Well Name: MESA 8105 JV-P	Well Location: T26S / R32E / SEC 1 / NESE /	County or Parish/State: LEA / NM
Well Number: 01	Type of Well: CONVENTIONAL GAS WELL	Allottee or Tribe Name:
Lease Number: NMNM14492	Unit or CA Name:	Unit or CA Number:
US Well Number: 3002527600	Well Status: Producing Gas Well	Operator: BTA OIL PRODUCERS LLC

Notice of Intent

Type of Action: Plug and Abandonment

## PLUG AND ABANDONMENT CONDITIONS OF APPROVAL

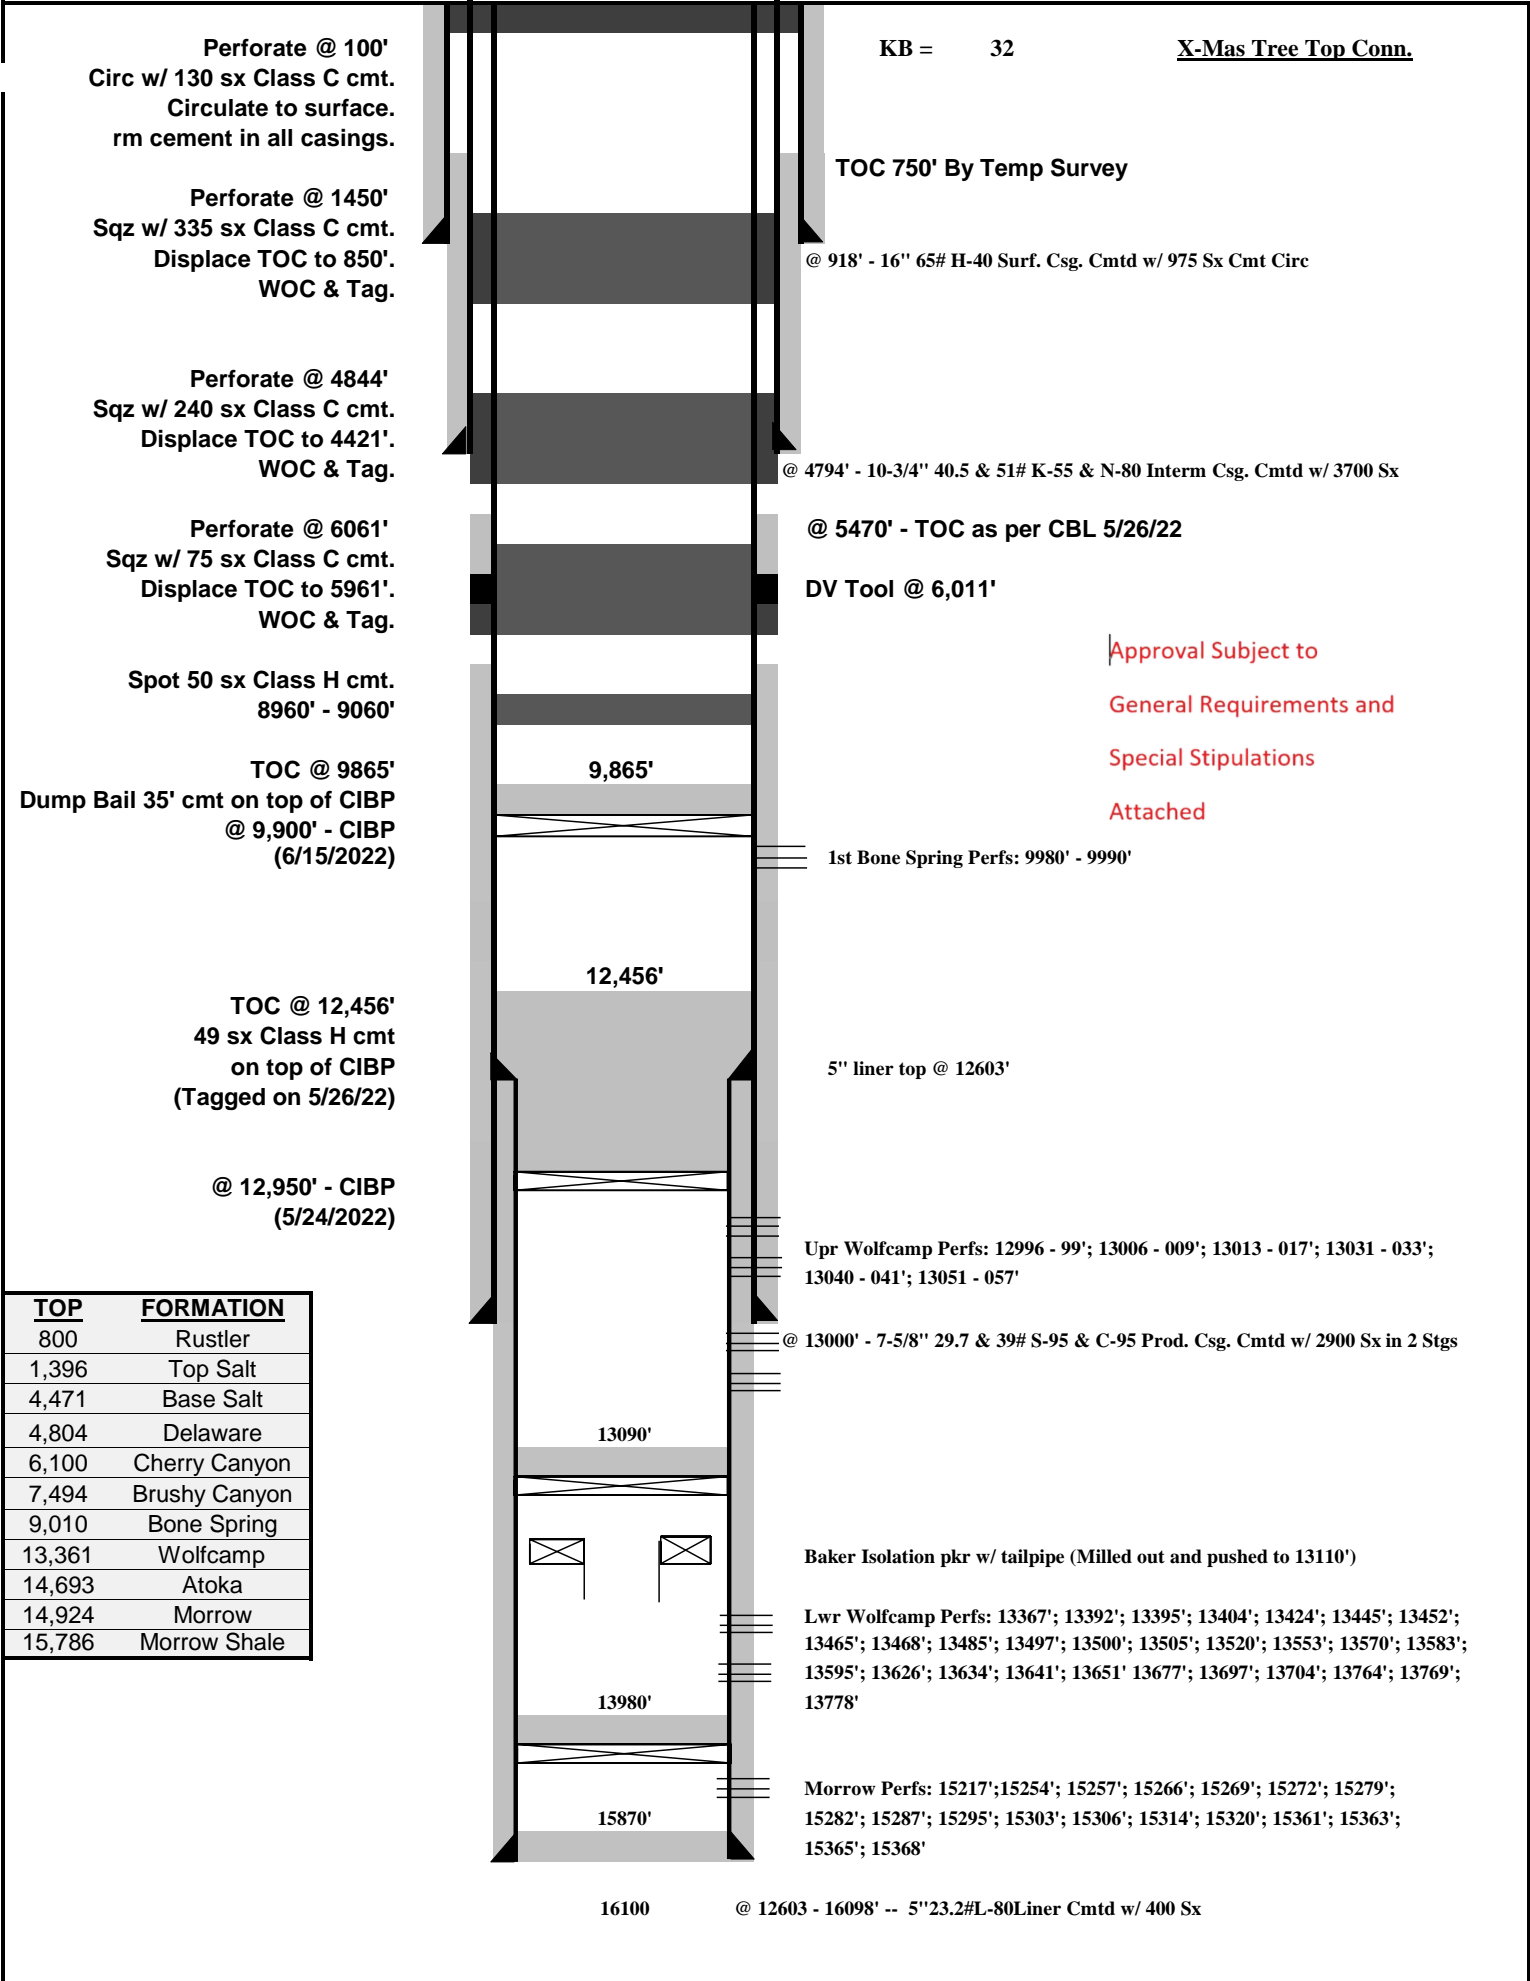
~~Pump 50~~ Perforate and attempt squeeze 80 sx Class H cmt @ ~~9334'~~ to 9141' 9060' — 8960'. (T/Bone Spring) WOC and Tag. (In/Out)

Perforate and squeeze 75 sx Class C cmt @ 6061'. Displace balance to ~~5900'~~ 5961'. WOC & Tag. (DV Tool)

Perforate and squeeze ~~240-155~~ sx Class C cmt @ ~~4844'~~ 4855'. Displace to ~~4421'~~ 4437'. WOC & Tag. (10-3/4" Csg shoe & B/Salt)

Perforate and squeeze ~~335-515~~ sx Class C cmt @ ~~1450'~~ 1440' to surface. ~~Displace to 850'. WOC & Tag.~~ (T/Salt & 16" Csg shoe) (In/Out) Verify at surface.

~~Perforate and squeeze 130 sx Class C cmt @ 100'. Circulate cmt to surface.~~

~~Spot 1" from surface to 200'. (Cement across all annuluses). Verify at surface.~~

- **No more than 3000 feet between cement plugs in cased hole.**
- **Wait on Cement and Tag Top of Cement Requirement:**
  - 1. Shoe, Top of Salt, Base of Salt, DV tool, Perforate and Squeeze, Open Perforation.**
  - 2. Formation plug is optional if a solid base is established and confirmed.**

Revised		API # 30-025-27600		Drawn	HD
		LEASE:	8105 JV-P Mesa	#1	6/27/2022
		FIELD:	Red Hills (Wolfcamp)		
		LOCATION:	1980' FSL 660' FEL Sec. 1 T26S R32E		Approved
		COUNTY:	Lea	STATE: New Mexico	
		PRODUCING FORMATION:	1st Bone Spring Sand		Date
		 BTA Oil Producers

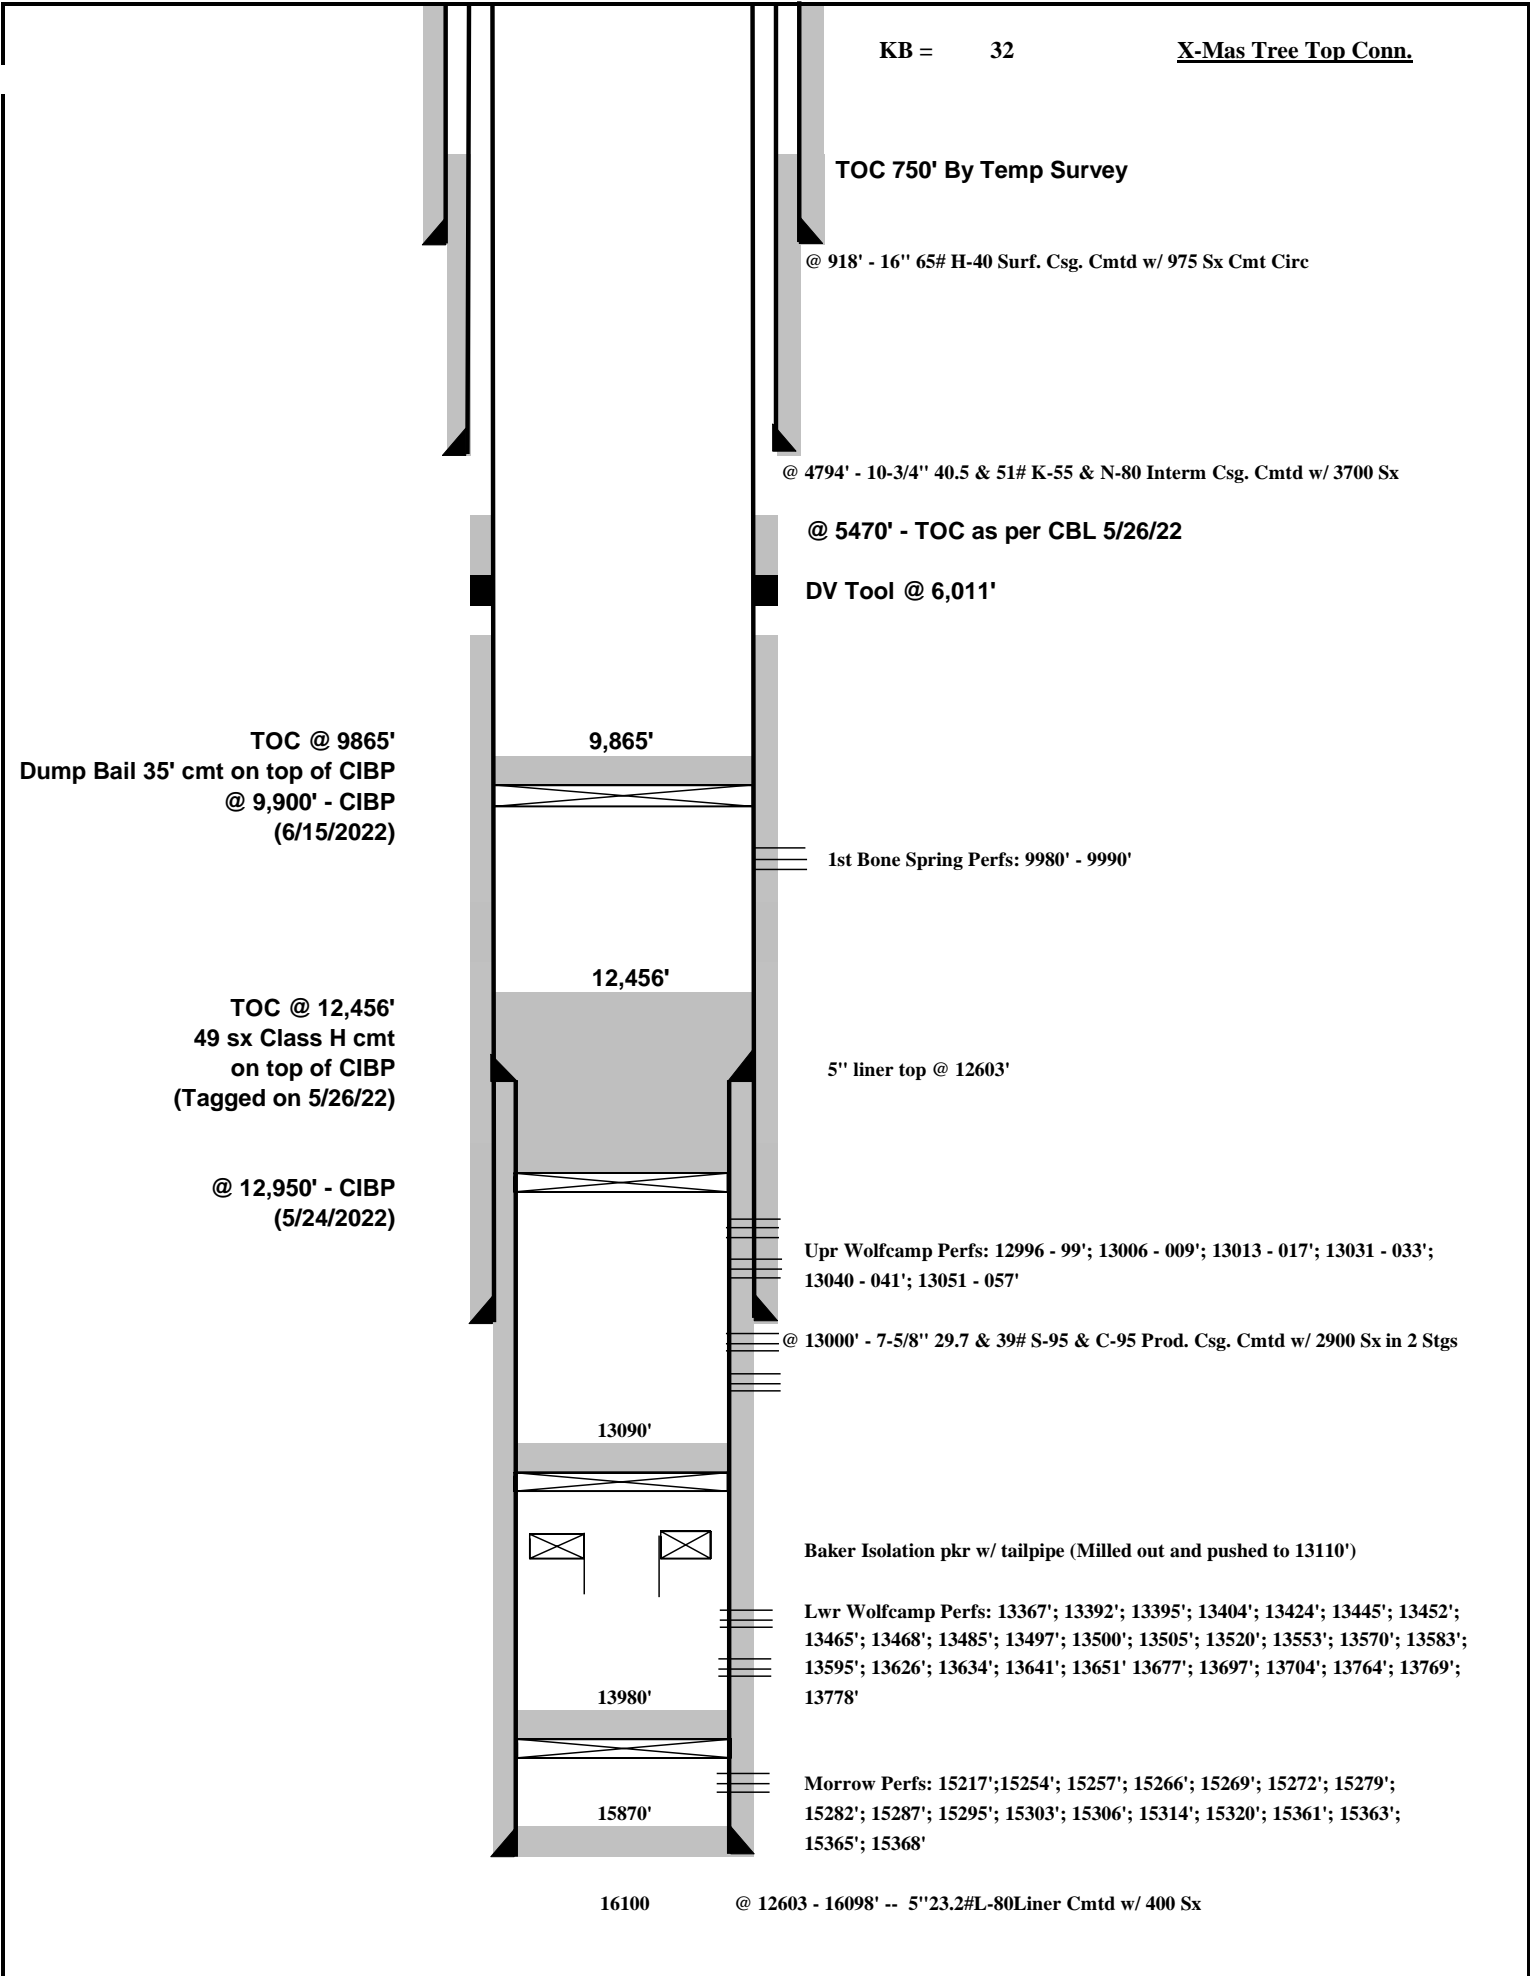
Plug Type	Top	Bottom	Length	Tag	Sacks	Notes
Surface Plug	0.00	200.00	200.00	Tag/Verify	100.00	Spot 1" from surface to 200' at surface. (Cement across all annulus). Verify at surface.
Fresh Water @ 804	745.96	1075.00	329.04	If solid base no		
Shoe Plug	858.82	968.00	109.18	Tag/Verify		
Top of Salt @ 1143	1081.57	1440.00	358.43	Tag/Verify	515.00	Perf and squeeze at 1440' to surface. Verify at surface. (In/Out)
Base of Salt @ 4533	4437.67	4583.00	145.33	Tag/Verify		
Shoe Plug	4696.06	4844.00	147.94	Tag/Verify		
Delaware @ 4805	4706.95	4855.00	148.05	If solid base no need to Tag (CIBP present and/or Mechanical Integrity Test), If Perf & Sqz then Tag, Leak Test all CIBP if no Open Perforations	155.00	Perf and Squeeze at 4855' to 4437'. (In/Out) Class C. WOC and Tag.
DV tool plug	5900.89	6061.00	160.11	Tag/Verify	32.00	Spot from 6061' to 5900'. WOC and Tag. Class C.
Bonesprings @ 9284	9141.16	9334.00	192.84	If solid base no need to Tag (CIBP present and/or Mechanical Integrity Test), If Perf & Sqz then Tag, Leak Test all CIBP if no Open Perforations	80.00	Perf and attempt squeeze from 9334' to 9141'. WOC and Tag. Class H. (In/Out)

If solid base no need to Tag (CIBP present and/or Mechanical Integrity Test), If Perf & Sqz then Tag, Leak Test all CIBP if no Open Perforations		Tag CIBP at 9865'. Leak test CIBP and spot 25 sx on top. Class H.
<b>CIBP Plug</b>	9830.00	9865.00	35.00		25.00	
<b>Shoe Plug</b>	12820.00	13050.00	230.00	Tag/Verify

**No more than 2000' is to be allowed between plugs in open hole, and no more than 3000' between plugs in cased hole.**
